Development Review Committee

1. Discussion: **Mission Rise PUD Rezoning Pre-Application**

MEMORANDUM

December 5, 2022
Mission Rise PUD – Pre-Application
Engineering Review Comments
Page 1

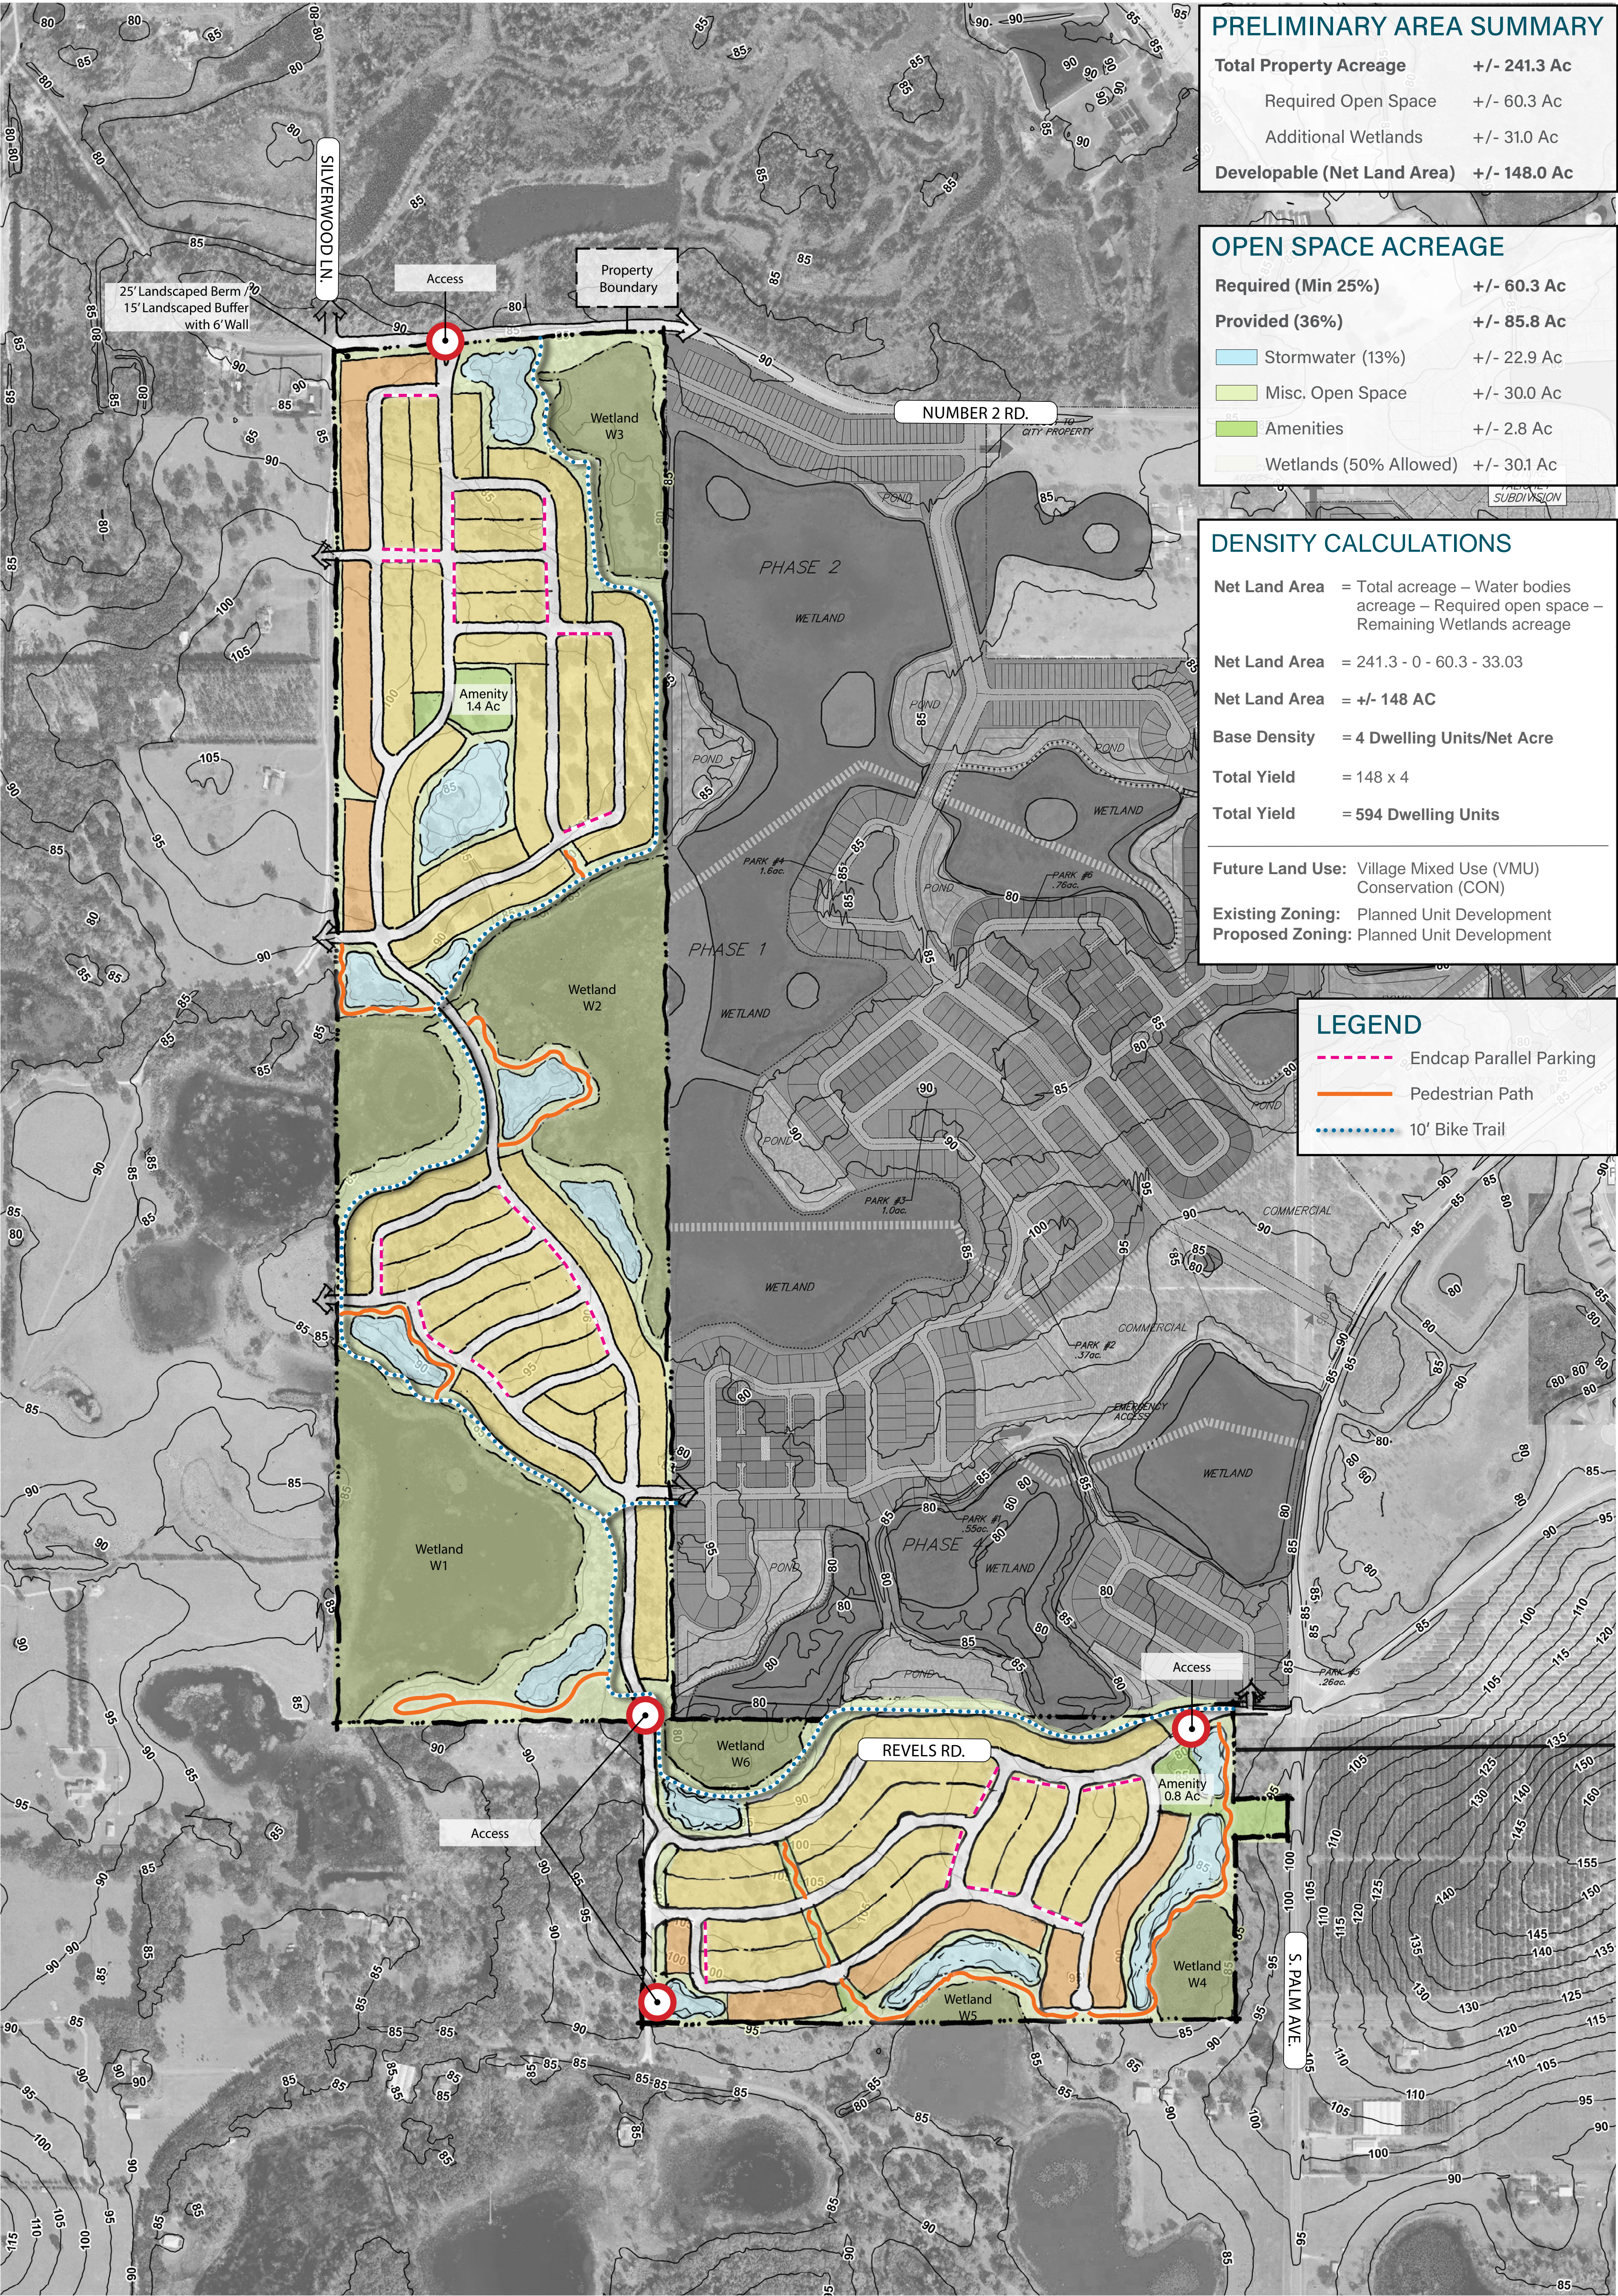
1. The density proposed is the maximum allowed by the code. Actual lot sizes are a policy decision for the Planning Board and Town Council to approve. Please note that recent Town Council action modified a project with lot widths proposed 65 feet and 70 feet to 75 feet and 80 feet respectively. The applicant may wish to consider how the project would fare with lot sizes in the 75 to 80 minimum range. Lot depths have been typically at 120 feet in the Town.

2. The Town Council has been seeking more space between units than typically provided with 50-foot lots. The Council appears to be supporting unit spacing of 15 to 20 feet which would yield a sideyard setback of 7.5 to 10 feet. This application supports the use of wider lots, and the applicant should consider this factor as well.

3. The proposed bike trail will need to be extended along Number Two Road to the eastern property boundary to connect to another trail segment. This extension may be within the Number Two Road right-of-way if acceptable to Lake County.

4. Lake County will require additional right-of-way for Number Two Road and will be the permitting agency for the intersection and other external road improvements.

5. Access points for vehicular use are appropriately located, with the following notes.
 - Revels Road will need to be improved from the project boundary to the intersection with Orange Blossom Road.

- The connection with The Reserve at Revels Road near SR 19 will need to be coordinated with the Hilltop Groves development.
 - At the northeast corner of the project at Number Two Road some coordination with access to deadend street in Hilltop Groves will need to coordinate access if there is any upland available.

6. Is the central collector road proposed as two-lane or four-lane facility? The design needs to plan for a median and turn lanes at intersections. Make sure the traffic study supports whichever option is chosen.

7. Can the layout be modified to eliminate or limit the number of residential lots that directly access from the primary collector road?
8. Is there any intent to consider any other housing types?

9. Is there any intent to consider housing options such as assisted living or nursing home?
10. The parcel has an opportunity to create a significant park area in the open space adjacent to Wetland Area 1 and link with bicycle and pedestrian trails.

11. Each neighborhood area should contain some type of appropriate park facility.
12. The amenity areas will need to be better defined to verify compliance with VMU standards.

13. A proposed buffer along Silverwood Lane is noted. This buffer needs to be in a separate tract to prohibit direct lot access to Silverwood Lane. The full plan should provide a conceptual design for the buffer including width, proposed plantings and any fence or wall that might be proposed.

14. Is there a proposed use, other than greenspace, for the project area directly abutting SR 19?

1. The main N-S spine road and realigned Revels Road should be a 2 lane divided boulevard using the same design section as Hillside Grove (Reserve) shown below. It shouldn't have driveway connections or on-street parking. It should have full pedestrian accommodation including the bike trail and raised crosswalks/speed tables at key points along its length connecting the trail and sidewalks to amenity, open space, and park areas.

2. The Binding Development Concept Plan should include the typical cross section for the N-S spine road and realigned Revels Road.
3. The project will require turn lanes on SR 19 at Revels Road and on Number 2 Road at the entrance.

4. The bike trail stub-out to Hillside Grove is not needed since there is nothing in their plan to connect to.
5. Show the FEMA floodprone line on the conceptual plan.
